NWBPCR Community Meeting #4 Report Out December 7, 2022

Manhattan Community Board 1 Battery Park City Committee

Provide responses to Community Board 1 to inform their resolution related to the Draft Scope of Work before the comment period for the Scoping Document ends on December 31. We will:

REACH 2
North
Esplanade

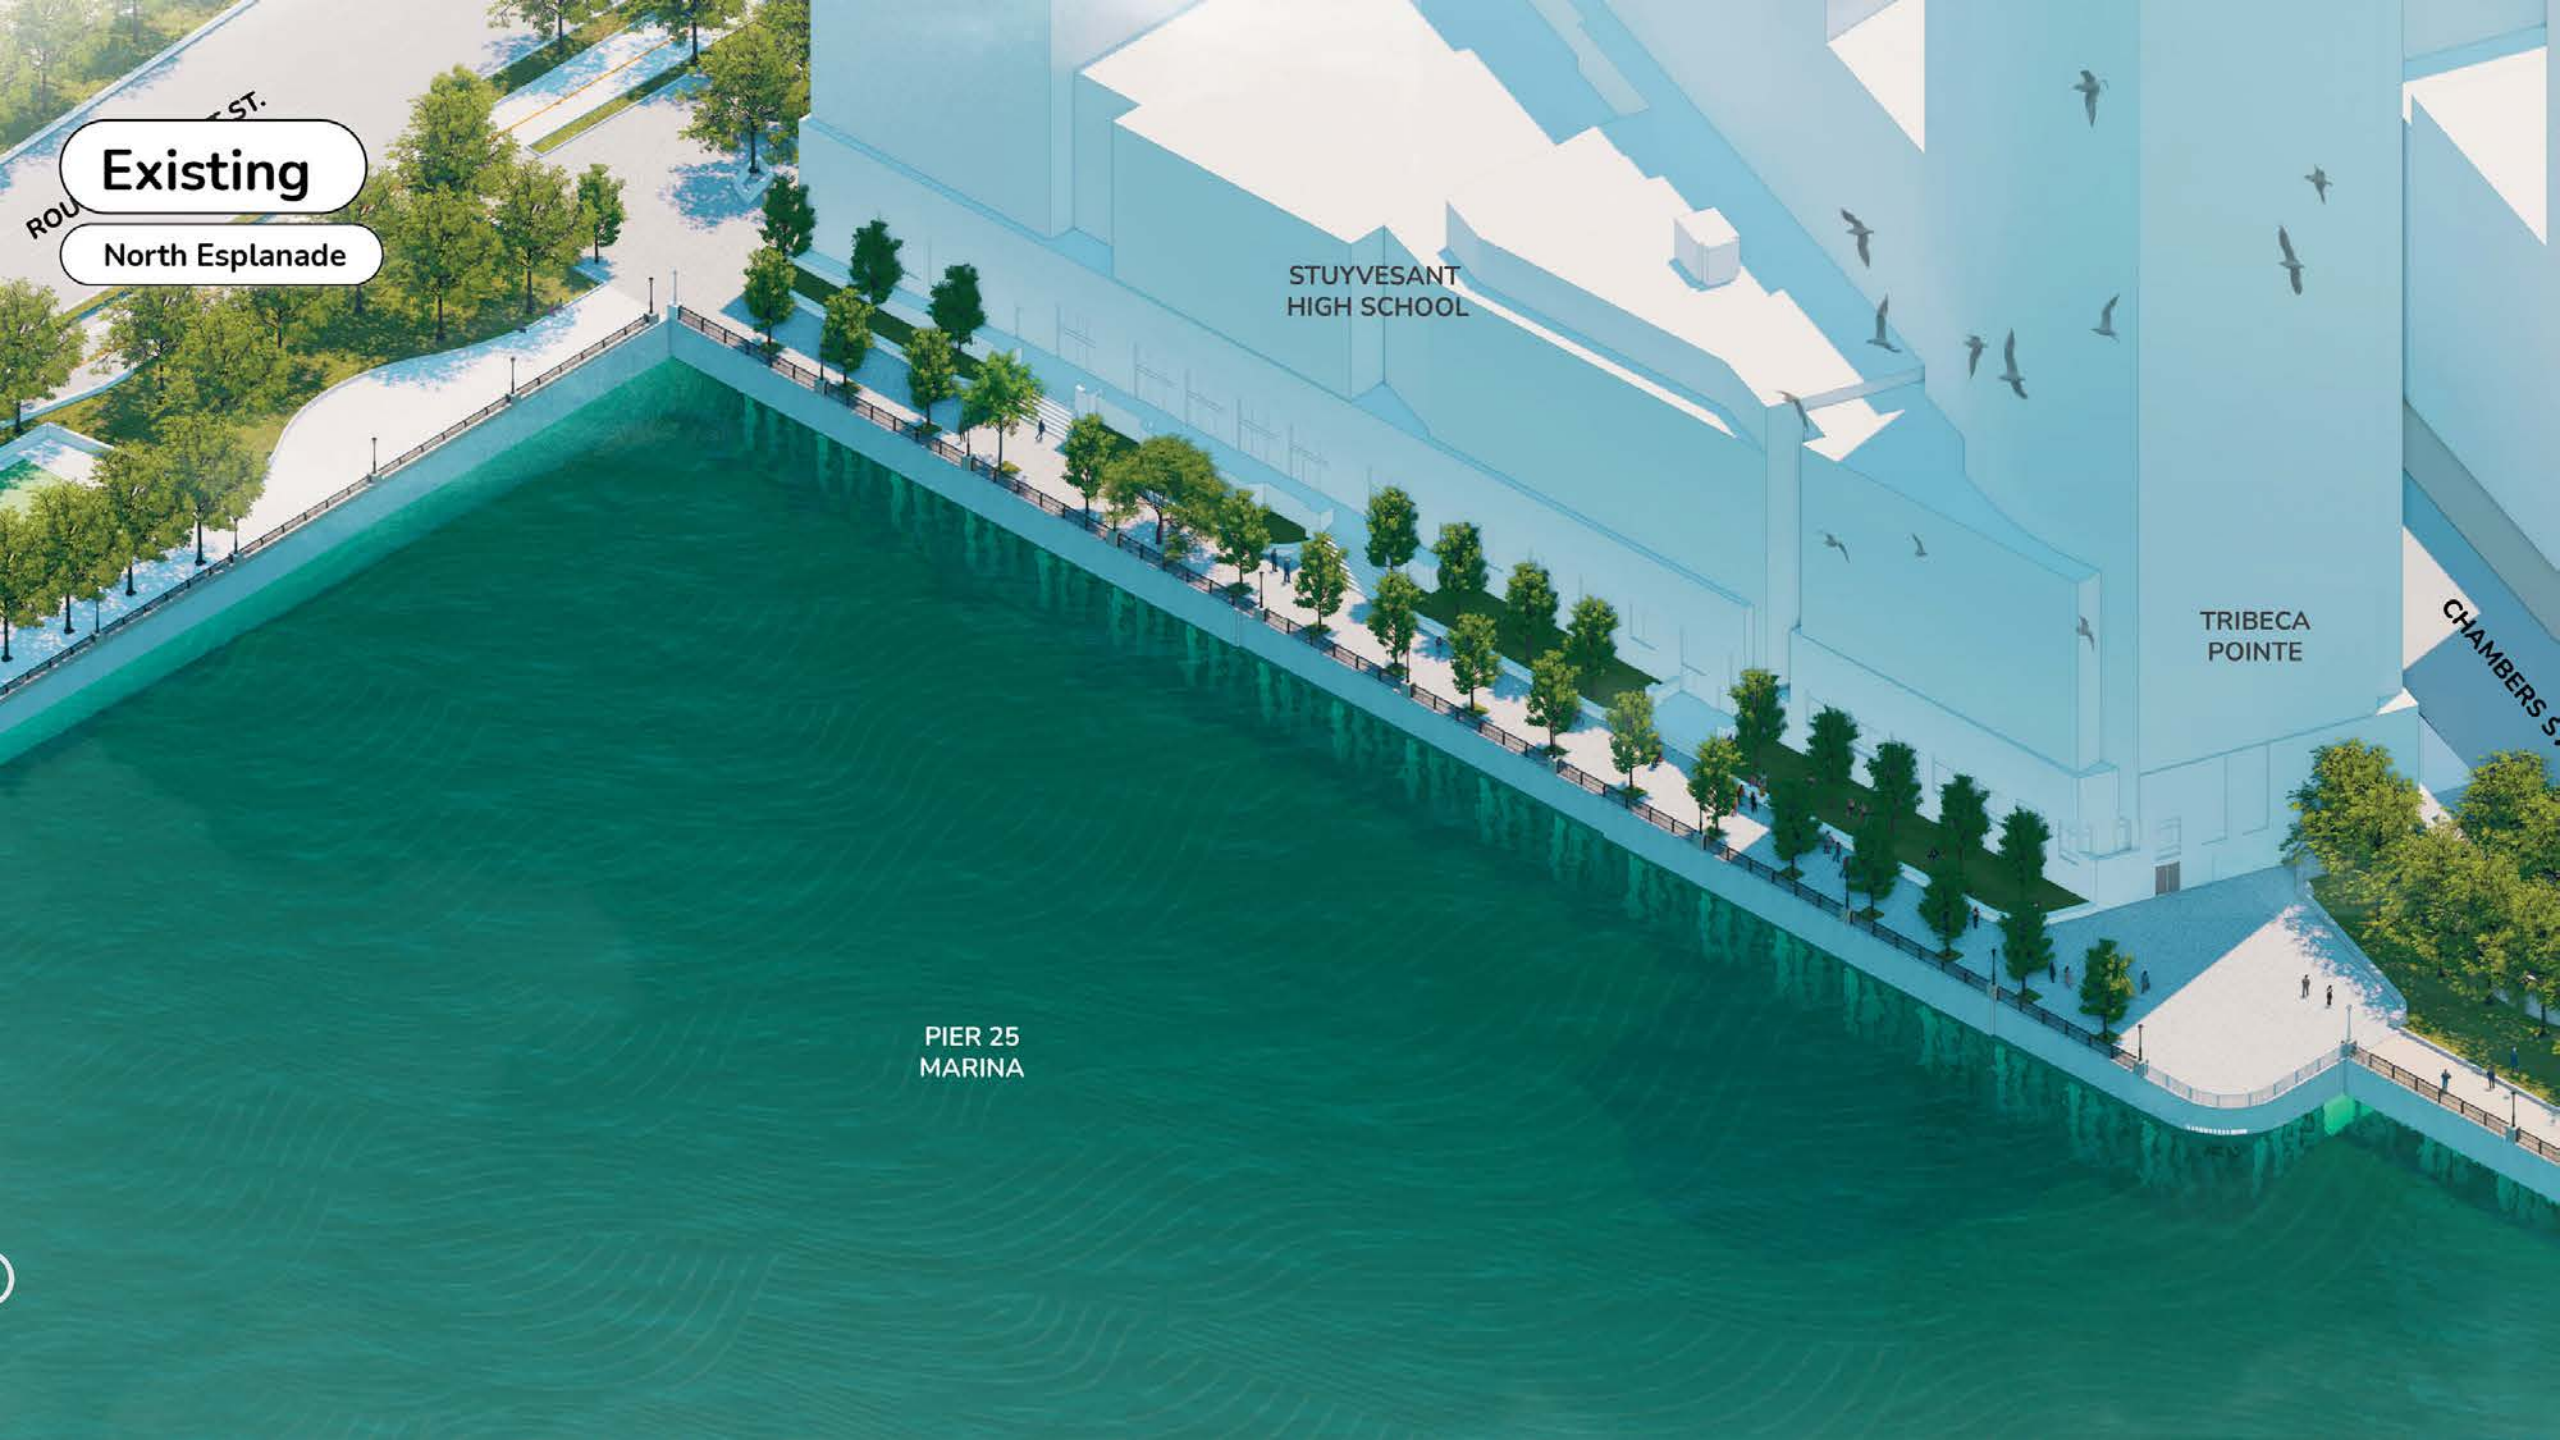
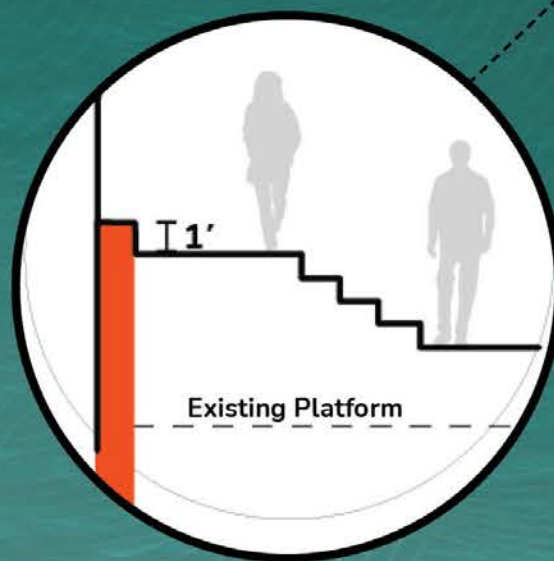
- Need to understand if more opportunity for nature based approaches like oysters, marshes etc. Also last open house, made a comment about a floating pool + Would like to see this option with pros and cons and presented to community for feedback.
- This pathway is commonly full with families and runners all summer. The wider pathway is important and necessary for the regular use of this space.
- Water access is a nice change. +1 for this option if the cost / work duration difference isn't significant.
- If the costs aren't prohibitive, seems worth the effort to expand this well used stretch including added natural elements, water interaction, and not mentioned above, but presumably either greater flood protection or lower flood wall requirements.

- Widened shared pathway and greater planting areas are worth the interagency coordination.
- Option 2B is preferable for several important reasons: actual access to the water for boating (not just seating by the water) and more options for greenery on a wider pathway.
- This is preferred if it's not cost prohibitive and doesn't significantly delay the overall project.

REACH 6
South
Esplanade

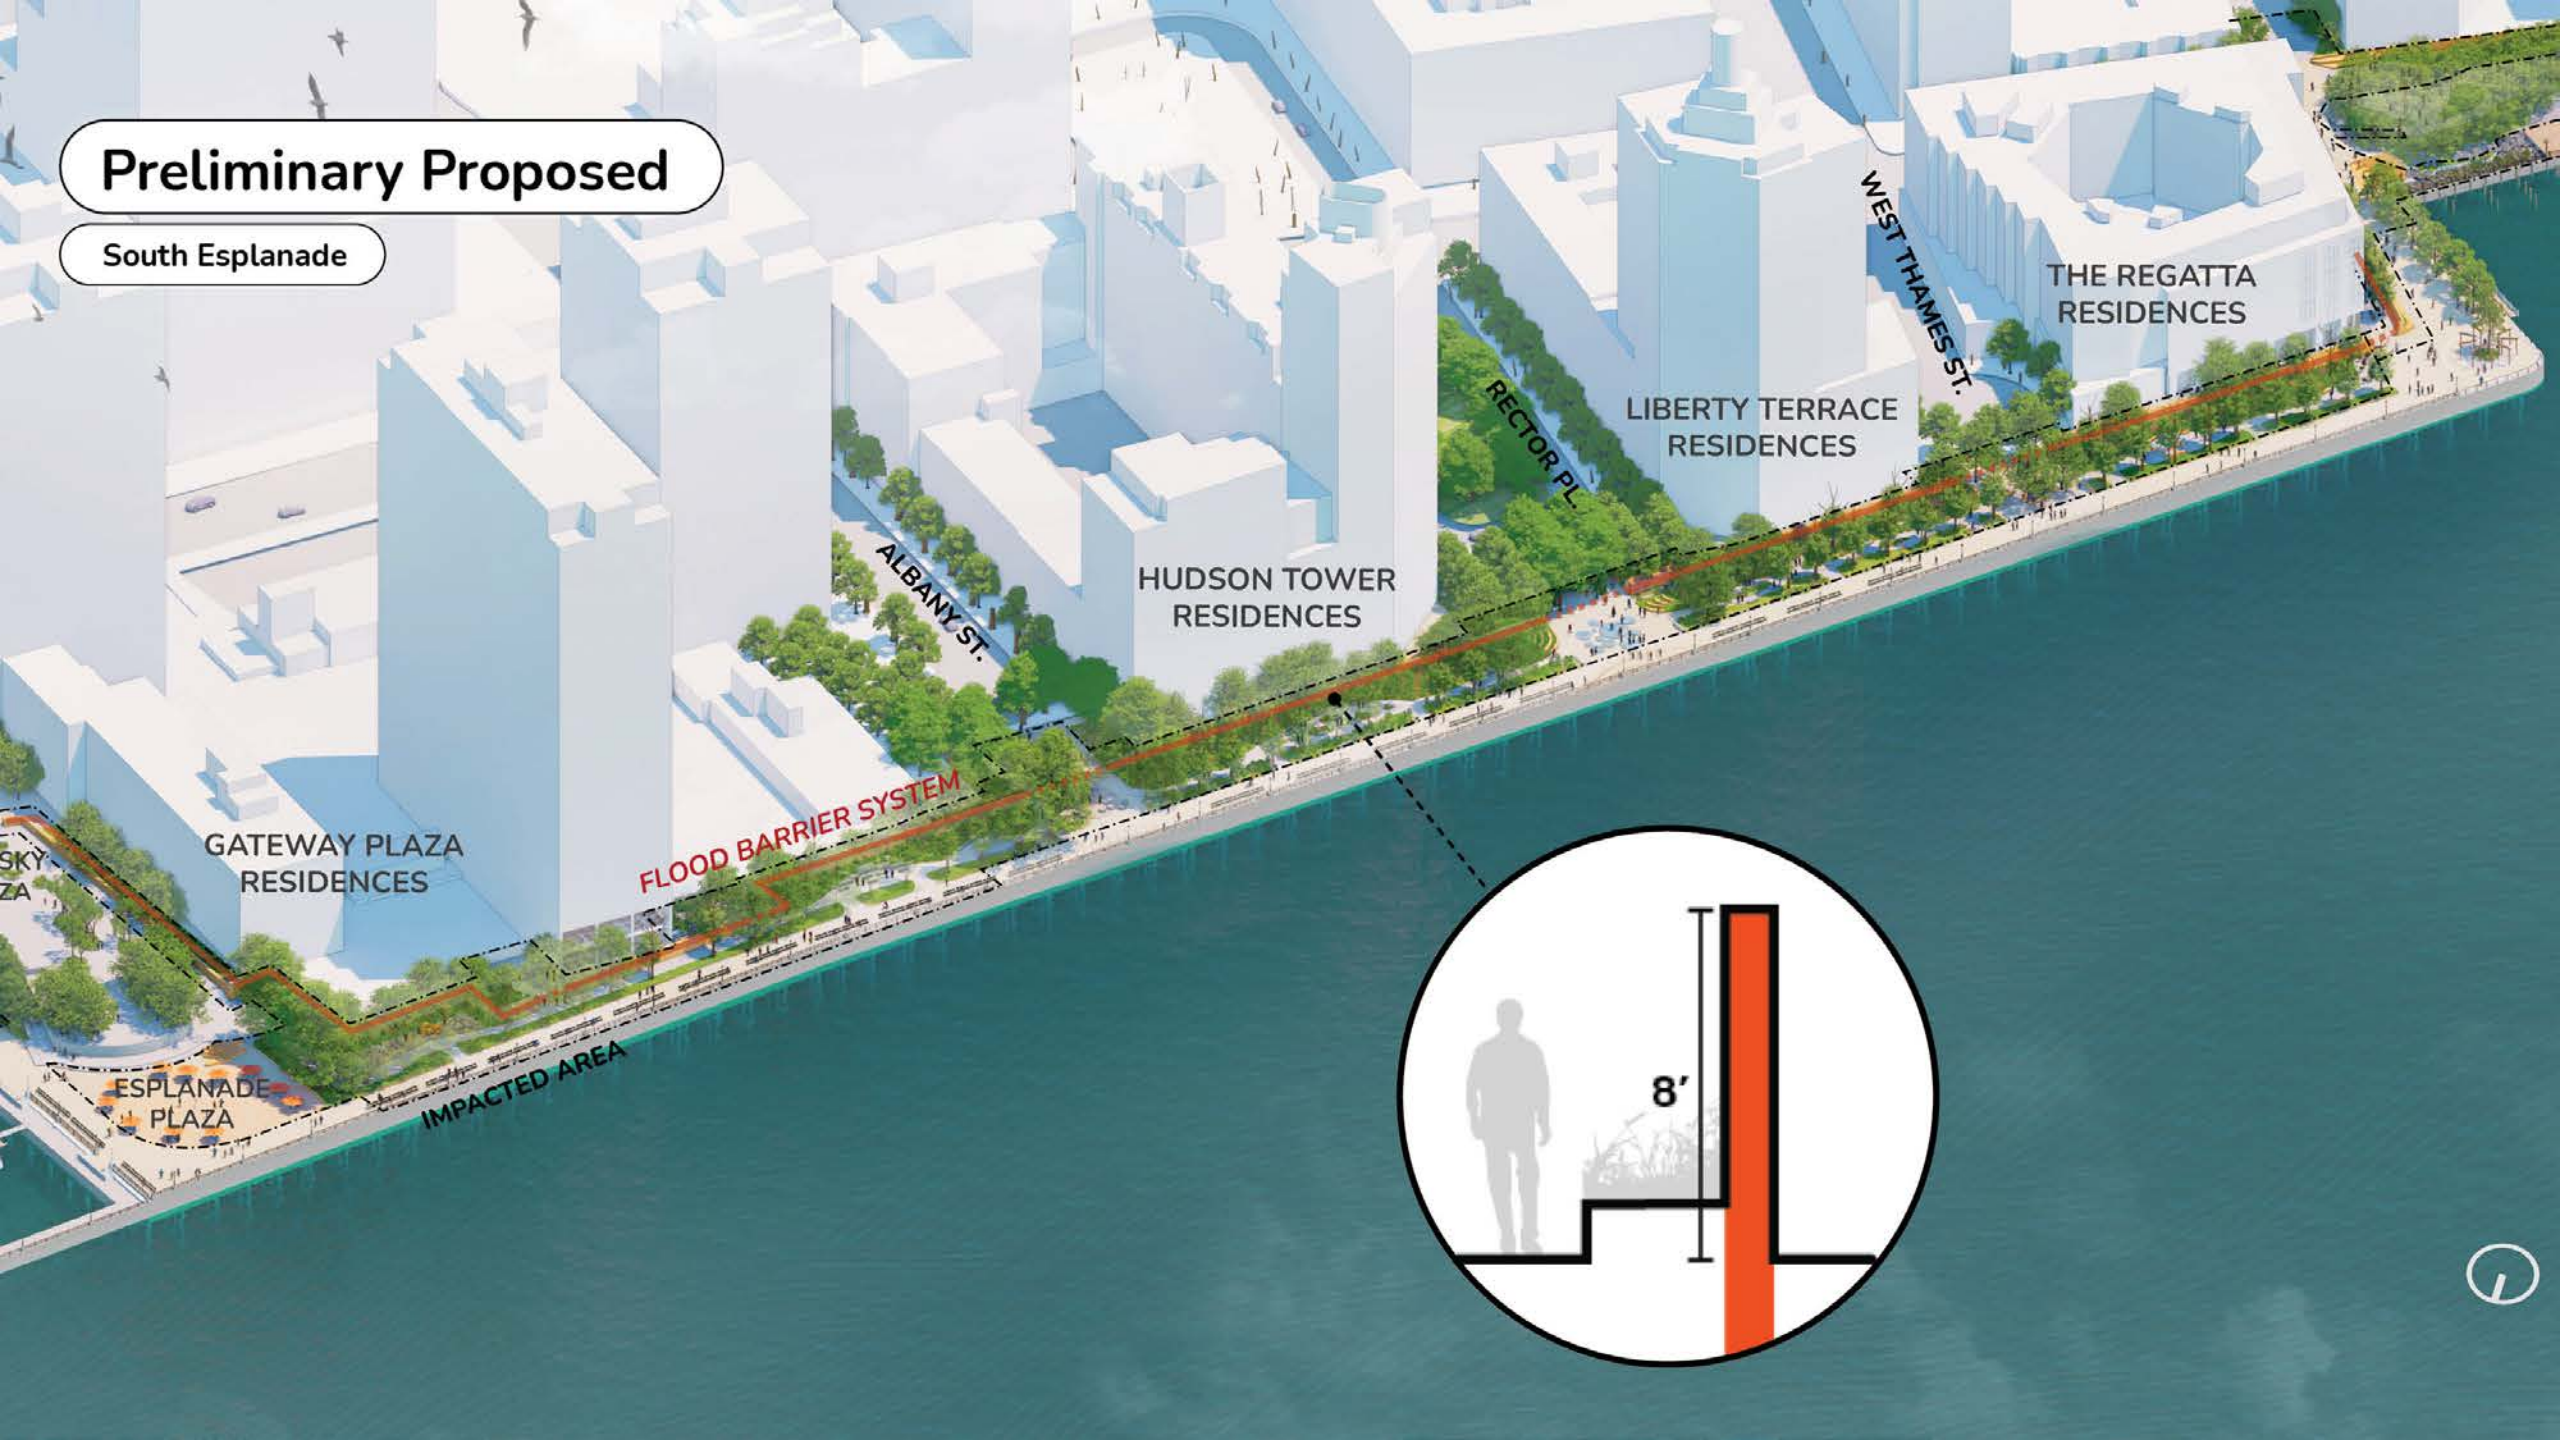
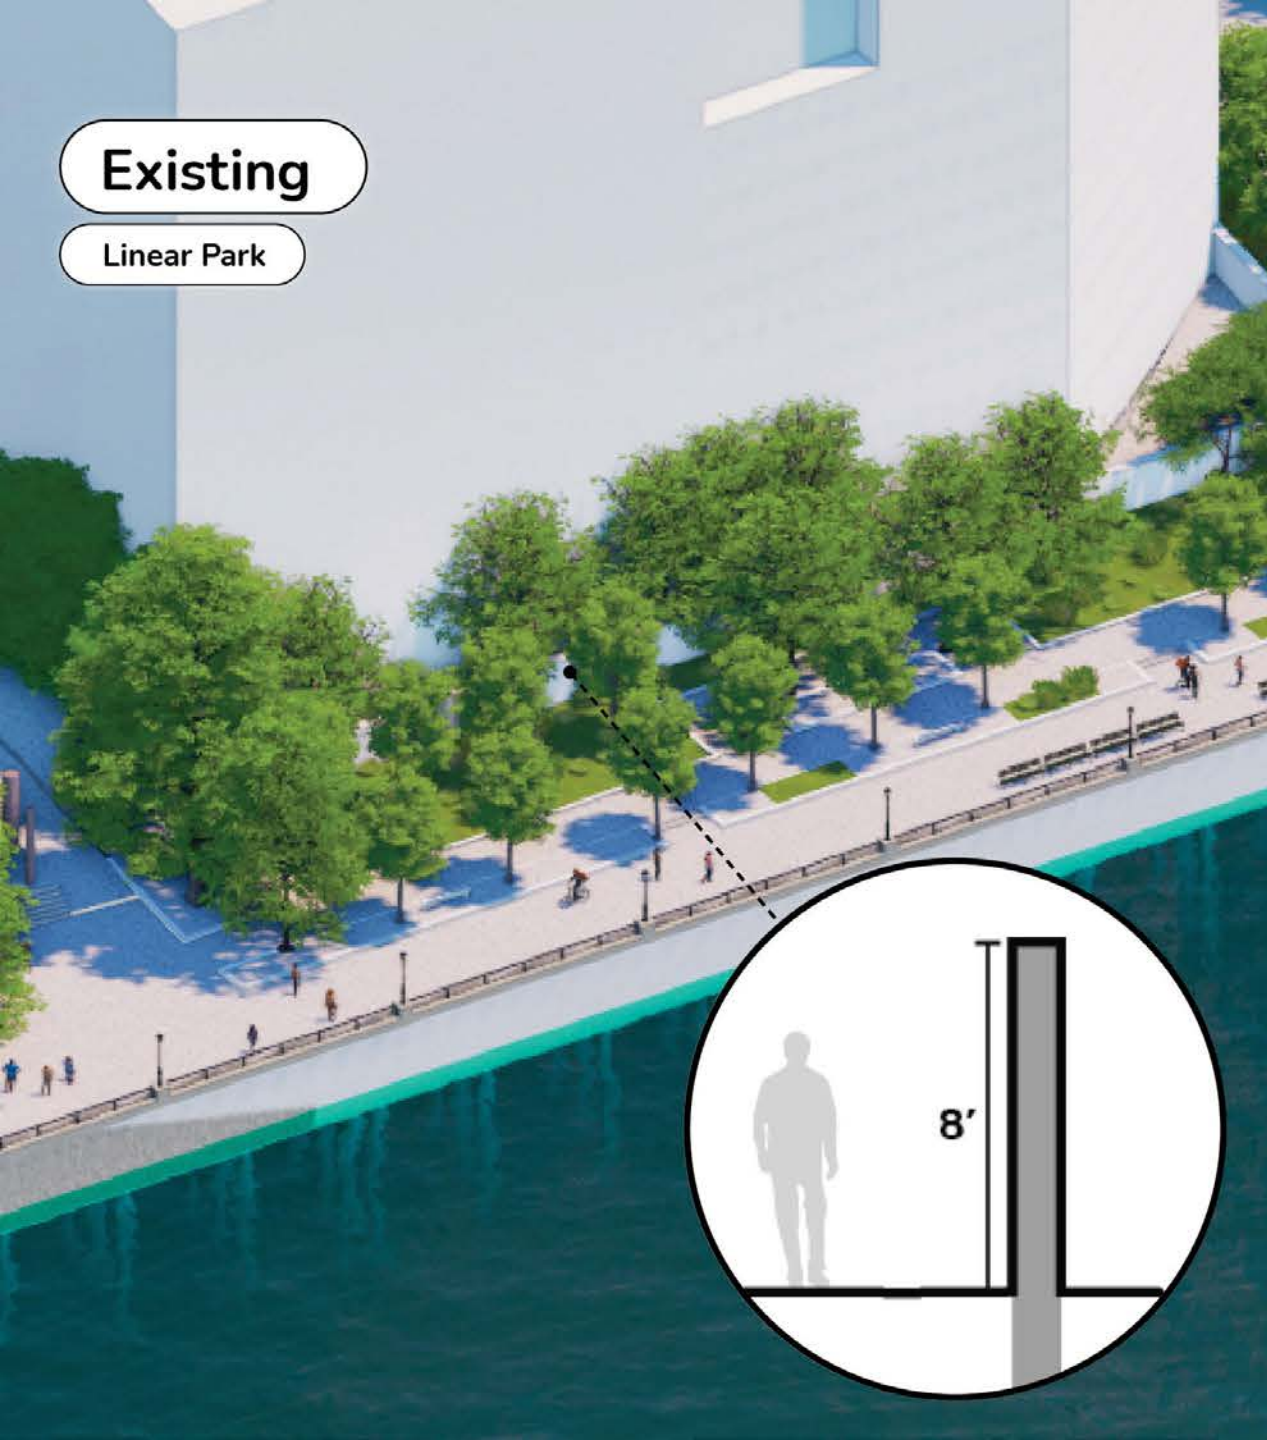
1. What do you mean by technical complexity? How is this a disadvantage? 6a appears from this brief description to be preferable to 6b for minimal impact. Please consult residences nearby for thoughts on the disruption to views.
2. Can you provide higher resolution pictures and include a comparison current state vs the future state, please also include elevations. Most of the buildings here have pretty high walls facing the esplanade - can you explain what will be different?
3. How will existing views be impacted?
4. Would it be possible to design the south esplanade open space to achieve more of a green footprint? This would bring it in line with the majority of the BPC areas that directly border the Hudson.

- 6a appears from this brief description to be preferable to 6b for minimal impact. Please consult residences nearby for thoughts on the disruption to views.
- This is definitely preferred– minimal disruption, less cost and construction duration, etc. All attempts should be made to keep at least some continuous path open during construction.
- Clear design principles of minimal disruption and preservation of mature trees.
- No, 6B is not a good option. We want minimal disruption and construction.
- Please ensure you get feedback from Jennifer Jones of Battery Park Montessori so you do not block all the windows for the kids in the school. I understand this is one of the more at risk areas because it was one of the first areas of fill and soil quality is low. It is why trees went down here in storms.
